**Subject: Swan Island Upland Facility
Operable Unit 2 Outfalls
ECSI No. 271**

On March 3, 2008, the Port of Portland (Port) submitted a February 13, 2008 memorandum prepared by Ash Creek Associates (ACA) that provided historical information on outfalls located on Operable Unit 2 (OU2) of the Swan Island Upland Facility. Between March 18, 2008 and April 29, 2008, the Oregon Department of Environmental Quality (DEQ) issued three comment letters regarding these outfalls. DEQ's comments are presented in italics, followed by the Port's response.

Outfall Locations

Operable Unit 2
Swan Island Upland Facility
Portland, Oregon

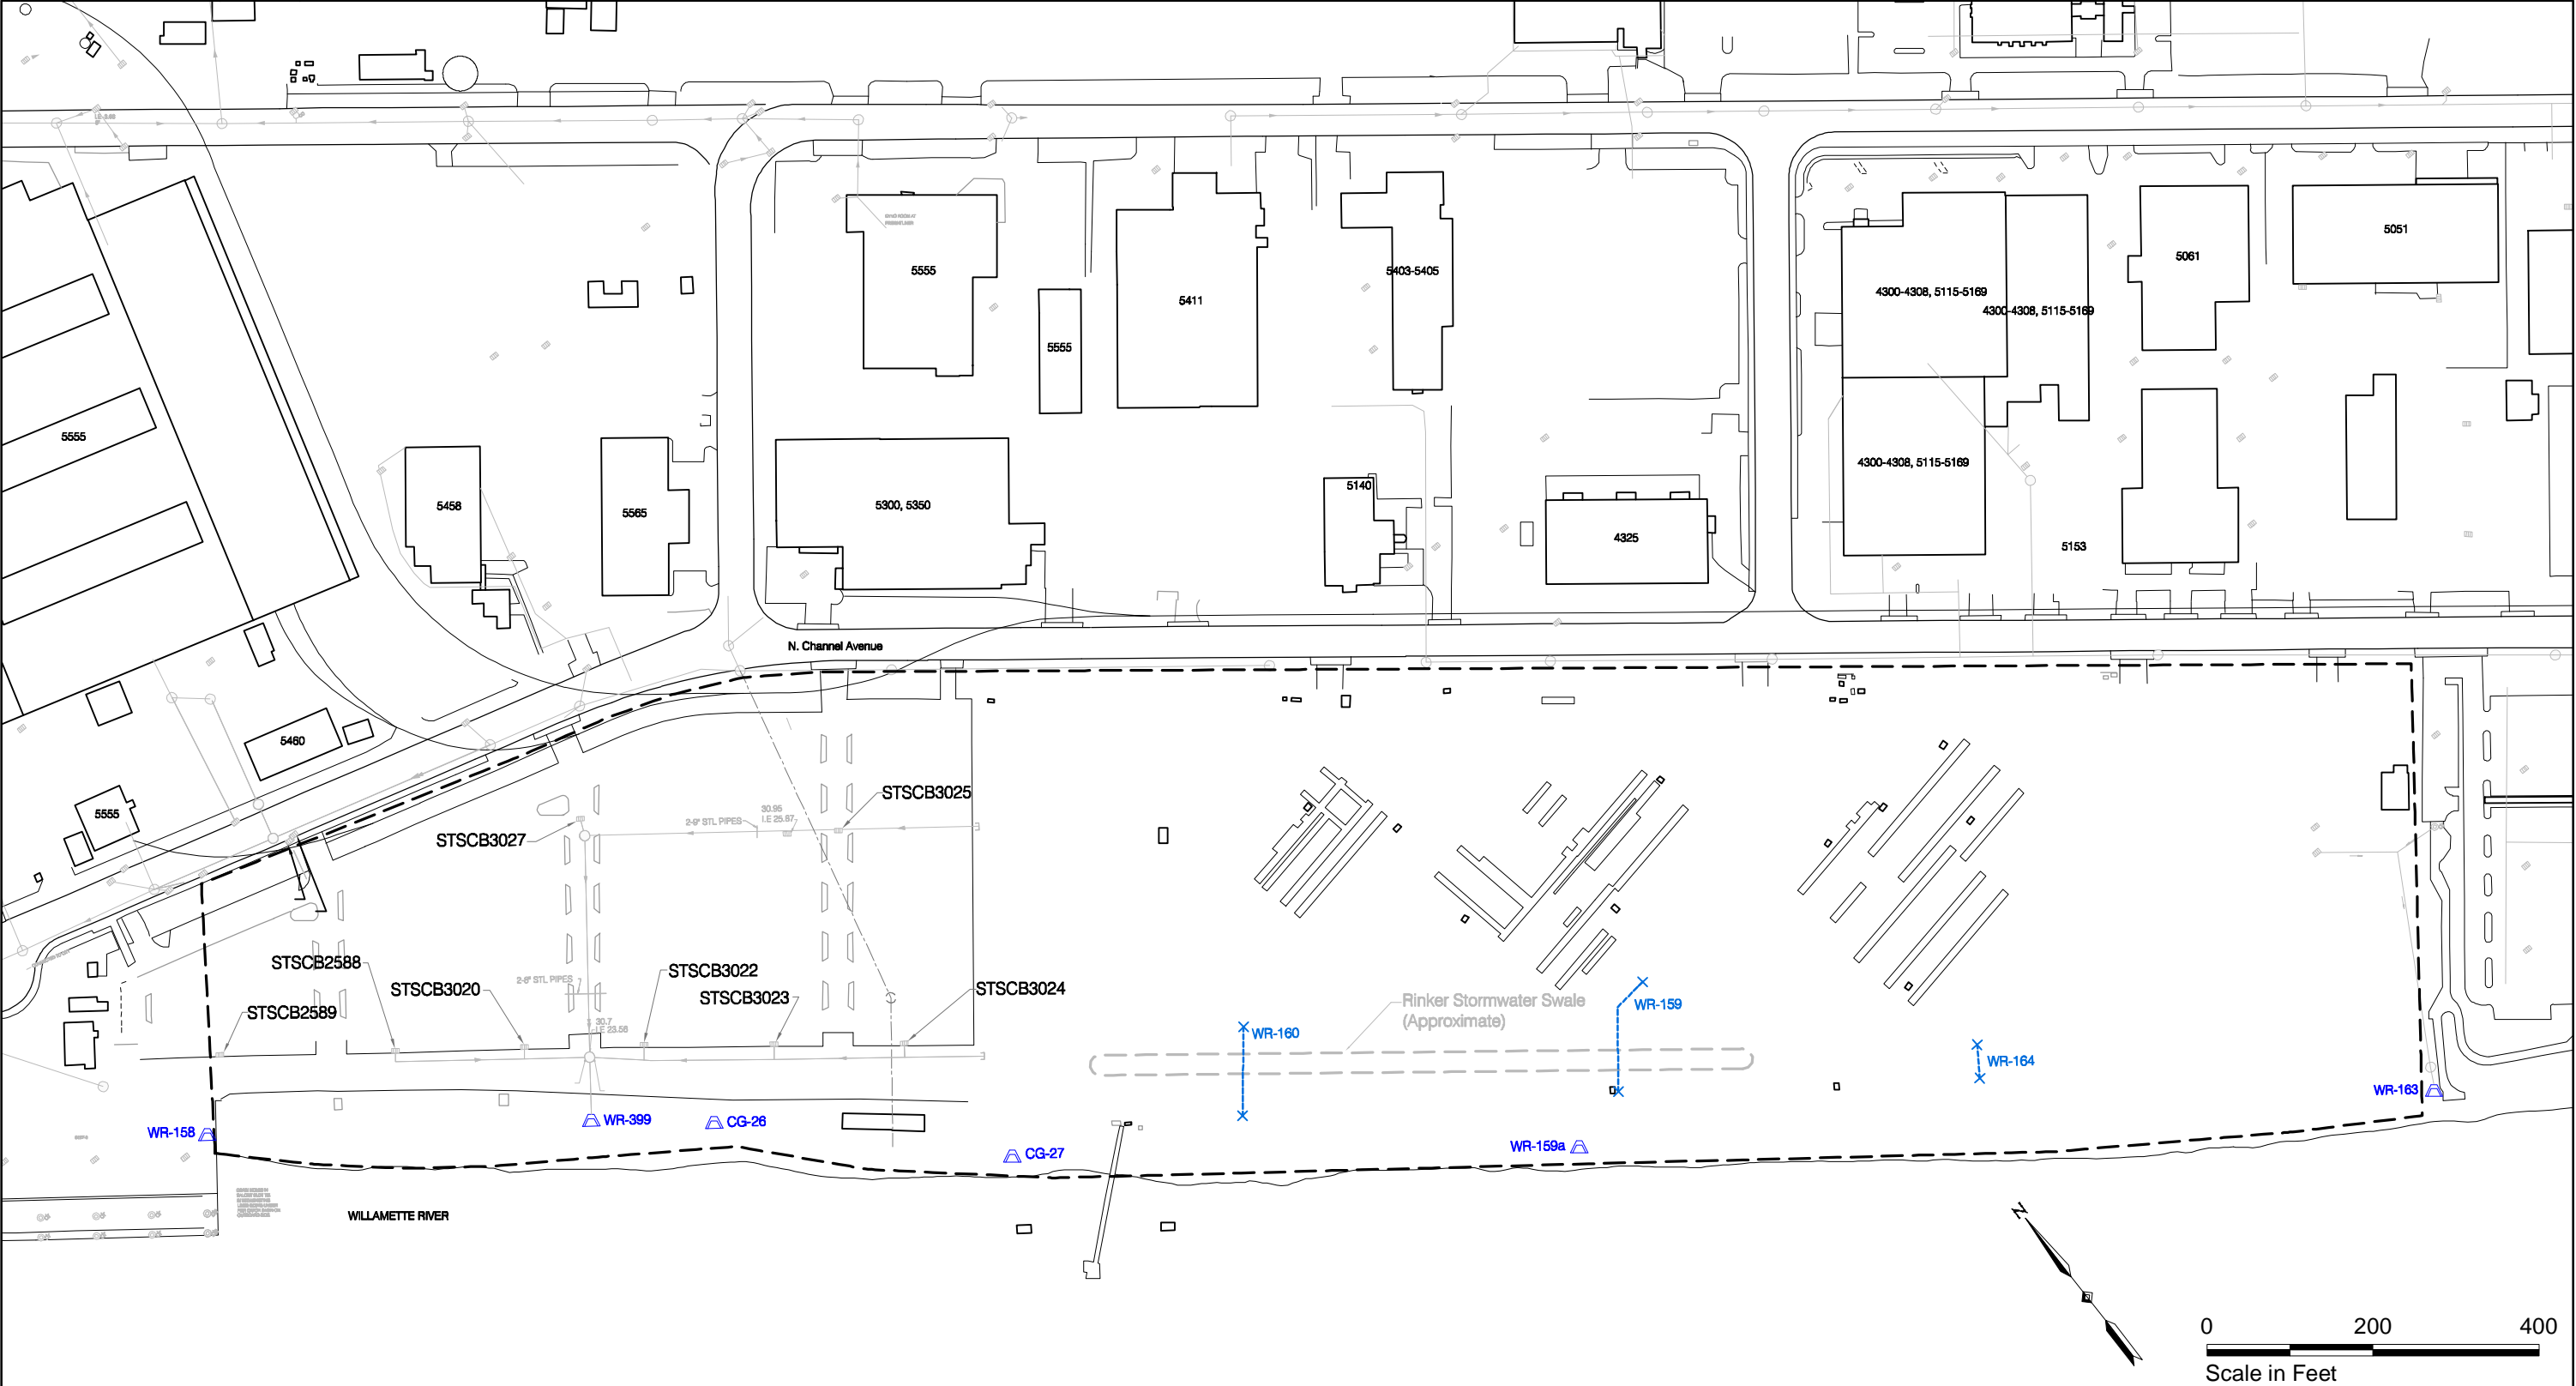
This letter provides some further clarifications regarding the outfall evaluation for Operable Unit 2. In our March 19, 2008 letter we suggested sampling of the shoreline in the vicinity of the outfalls to assess if there is contamination associated with stormwater discharge that could erode into the river. We did not require this sampling because we assumed that this area was outside the definition of the upland site and would not be part of the source control evaluation. However, because it has been determined that a portion of the beach area along the shoreline lies above the Ordinary High Water (OHW) line of the Willamette River (the boundary for the upland facility as specified in the Voluntary Agreement between the Port and DEQ, LQVC-NWR-06-07), we are requiring the sampling to fully evaluate whether erosion of shoreline soil is a pathway that will need to be controlled as part of the source control evaluation for this site. Should contamination associated with the outfalls be identified at levels that could pose a threat to the river, we note that the most sensible approach to addressing this localized source area might warrant sampling and potentially cleanup below the OHW.

The Port will collect riverbank samples beneath those outfalls with an invert above the OHW line, as is the case for outfalls WR-399, CG-26, CG-27 and WR-159a (Figure 1).

These outfalls are located approximately 10 feet or less, from the top of the riverbank. The end of outfall WR-163 discharges to the Willamette River near the bottom of the riverbank, below the OHW line. The sampling approach to be used at outfalls WR-399, CG-26, CG-27 and WR-159a will be consistent with the approach previously used at the three stormwater pipes that were removed by the Port in 2006 (i.e., outfalls WR-159, WR-160 and WR-164).

As requested in Comment 2 of DEQ's March 18, 2008 letter, the Port did consider the proximity of outfall WR-159a to former outfall WR-159 in its evaluation of shoreline sampling in the vicinity. It appears that outfall WR-159a is not close enough to former outfall WR-159 to allow the riverbank sampling results for outfall 159 to be used for outfall WR-159a.

Three soil samples will be collected from the riverbank below each outfall. The samples will be labeled "a", "b" and "c." The "a" sample will be collected near the top of the riverbank just below the end of the outfall. The "c" sample will be collected at an elevation corresponding to Ordinary Low Water², or approximately one to two feet above the river, whichever is lower. The "b" sample will be collected approximately halfway down the riverbank between the "a" and "c" samples.

Aliquots of each "a", "b" and "c" sample will be combined in the laboratory to create a single composite sample for each outfall. The discrete samples will be retained. Because outfall WR-159a may have drained the same portion of OU2 as the three stormwater pipes (WR-159, WR-160, and WR-164) that were removed in 2006, the composite sample collected at outfall WR-159a will be analyzed for the same constituents as the samples collected below the three stormwater pipes: metals (antimony, arsenic, cadmium, chromium, copper, lead, nickel, silver and zinc), total petroleum hydrocarbons, polychlorinated biphenyls (PCBs) and polynuclear aromatic hydrocarbons (PAHs). The samples collected below the other three outfalls (i.e., WR-399, CG-26 and CG-27) will be analyzed for the following constituents.
